Interior Renovations Phase 2 Murray Centennial Public School

ADDENDUM NO. 1

Addendum No. A-1

Project No.: **KPRDSB Tender No. PUR18-023-ITT (AECOM #60533591)**

1 RCP-LIBRARY 114

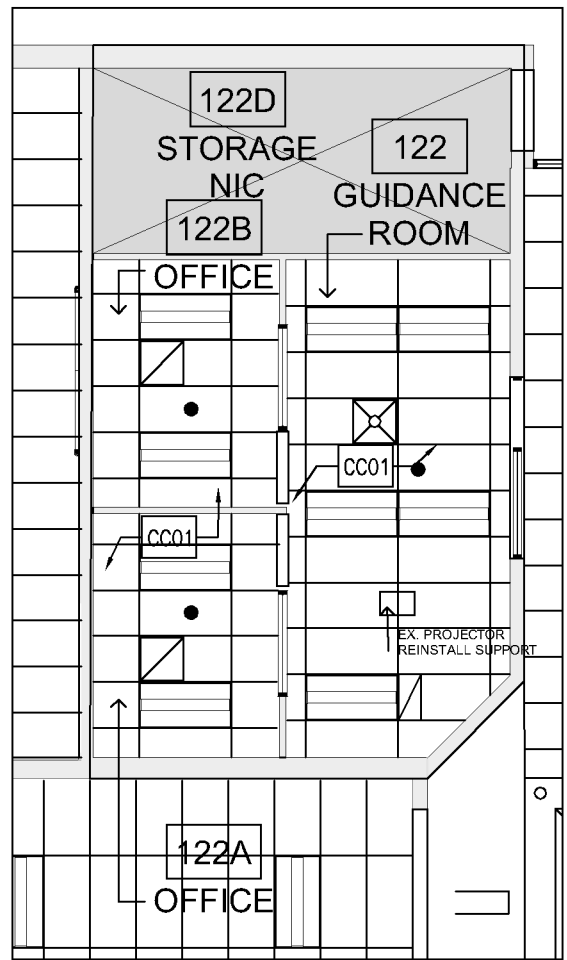
- 11.** Reference: Drawing A-104, Library #114
Delete: Existing ceiling grid only.
Add: New ceiling grid only (CC08). Reinstall existing acoustic tiles in new grid. Typical for north and south Library 114 sections only.
Revise: Replace existing ceiling grid and acoustic tiles with new acoustic ceiling system (CC01) as specified. Typical at narrow easterly/centre Library 114 section. Refer to attached sketch SK-01, Detail 1.

2 RCP-GUIDANCE AREA

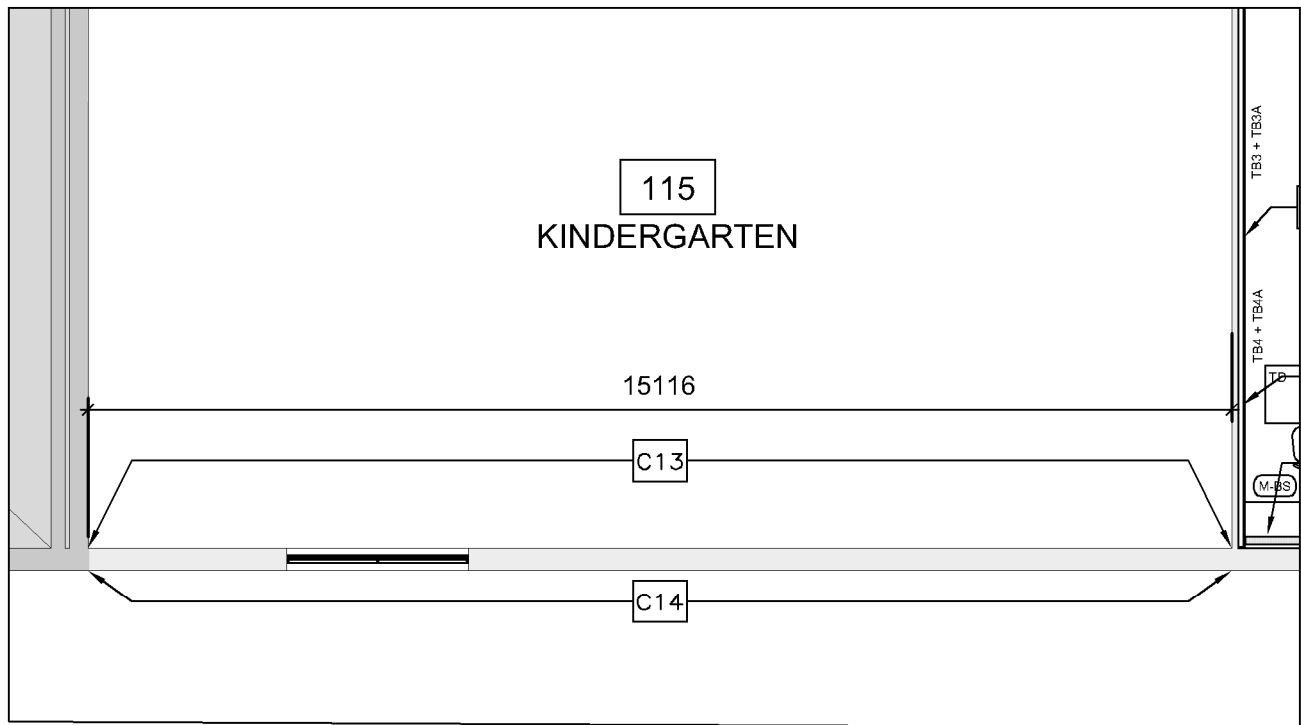
- 10.** Reference: Drawing A-104, Guidance Area
Add: New suspended acoustic tile ceiling system (CC01) (as specified) in the following rooms: Guidance #122, Office #122A, Office #122B
Refer to attached sketch SK-01, Detail 2

1 KINDERGARTEN 115

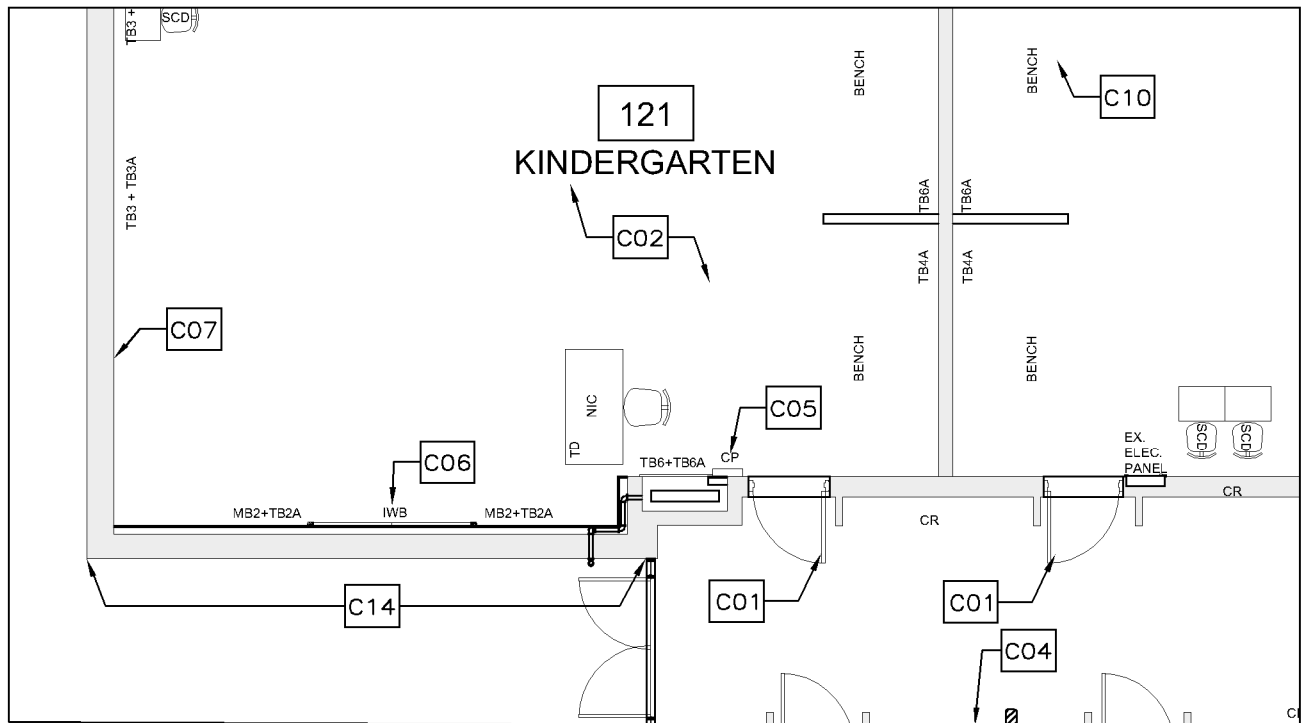
6. Reference: Drawing A-102 and A-103, Construction Note Schedule,
(Refer To Attached Sketch Sk-02, Detail 1 and 2)
Add: Construction note C14
Construction note C14 to read as follows:
REMOVE EXISTING SEALANT BETWEEN TOP OF BRICK AND PRECAST
PANEL (VERT. & HORIZ.). INSTALL NEW SEALANT AS SPECIFIED. APPLY
NEW SEALING COMPOUND COATING. PRODUCT: INTRAGUARD BY W.R.
MEADOWS OR APPROVED EQUAL.

- 8.** Reference: Drawing A-101, A-102
Add: Construction Note #C13 to interior south wall in Kindergarten 115 as shown on attached sketch SK-02, detail 1.

2 KINDERGARTEN 121

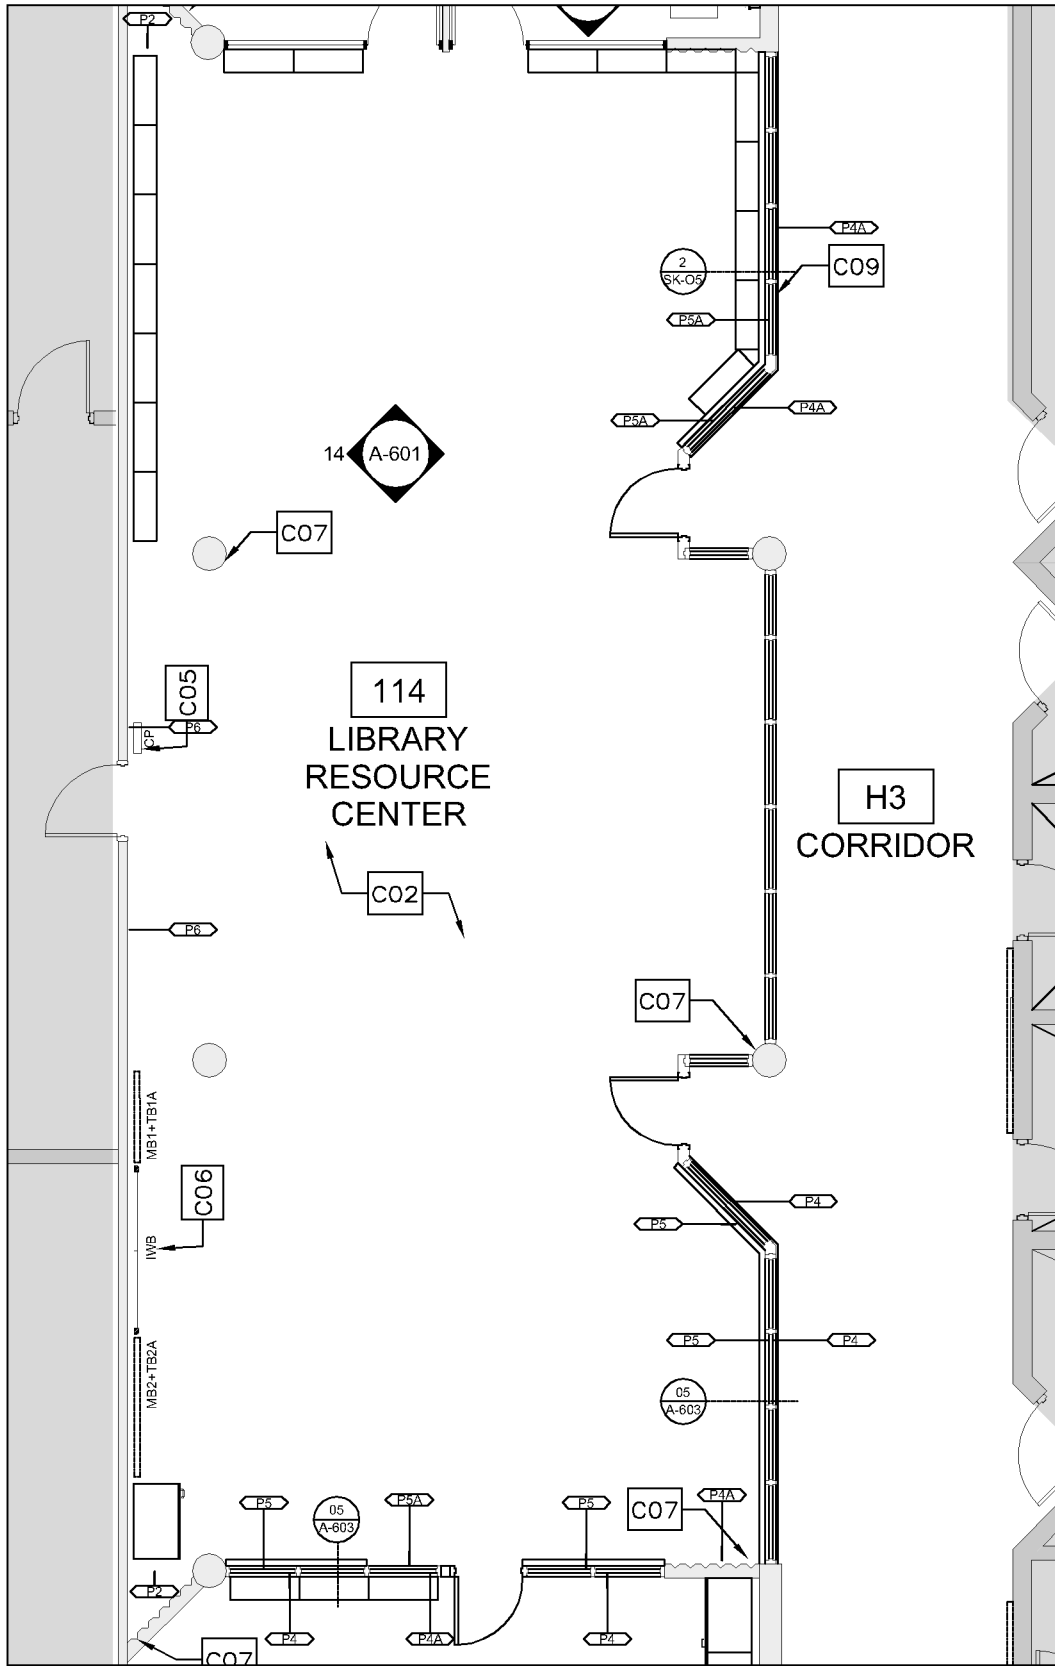
- 9.** Reference: Drawing A-101, A-102
Add: Construction Note #C14 to exterior wall as shown on attached sketch SK-02, detail 2. Refer to attached sketch SK-02

1 PLAN - LIBRARY 114

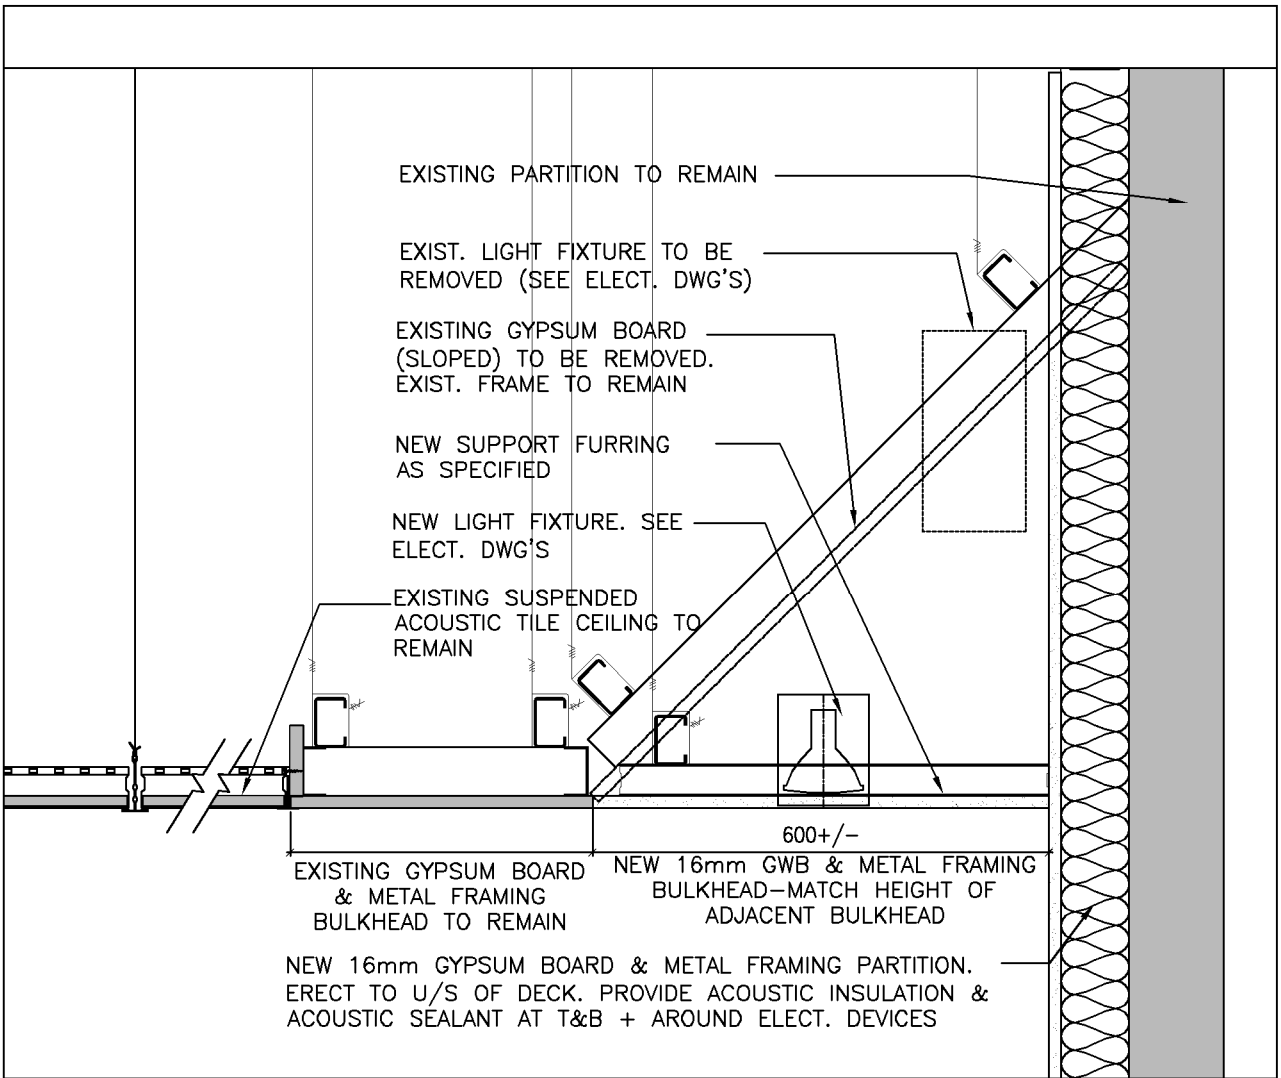
14. Reference: Drawing A-103, Detail 1

Add: Wall type identifications as shown on attached sketch SK-03, detail 1.

1 LIBRARY PARTITION DET.
 SK-05 REFERENCE DWG.: A-603, DET. 5 Scale: 1:10

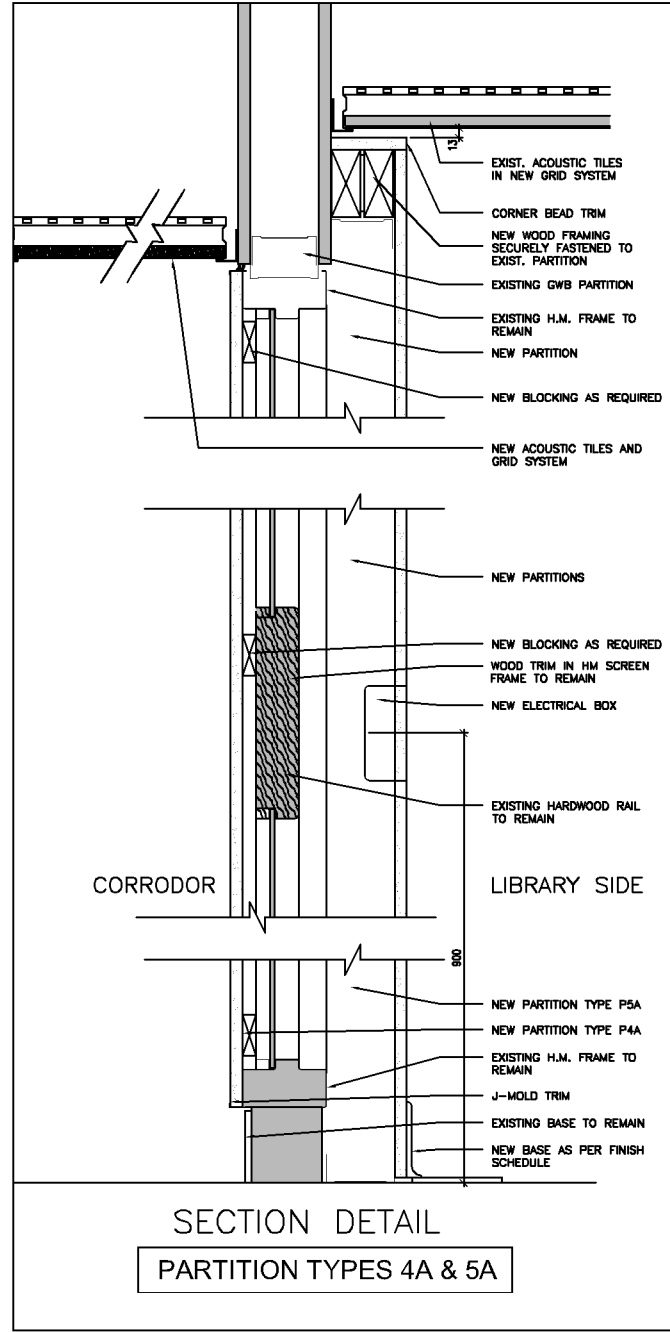
- 12.** Reference: Drawing A-001, Assemblies, Walls and Drawing A-603, Detail 5
Revise: Wall Type P4
Delete: 64mm Furring Channels (refer to attached sketch SK-05, Detail 1)

- 13.** Reference: Drawing A-001, Assemblies, Walls
Revise: Wall Type P4A
Delete: 64mm Furring Channels (refer to attached sketch SK-05, Detail 2)

Question: Room Finish Schedule on A-603 calls out for Terrazzo floor finish and base in corridor H3.
Detail 5, A-603 Library partition detail shows a rubber base.
Existing condition appears to be black tile.
Please clarify intended finish.

Answer: All Corridors are existing terrazzo floor with existing terrazzo and/or ceramic tile.
There is no work included with regards to these areas and will remain as is.
Detail 5/A603 shows a new rubber base on new stud partition. This detail pertains to the two screens adjacent to the Library only (see section reference on detail 1/A103). Detail 5/A603 is no longer applicable as the detail has been revised to eliminate the rubber base and stud partition from the floor area (Partition raised above the existing base).
A revised detail is included in this Addendum # 1.
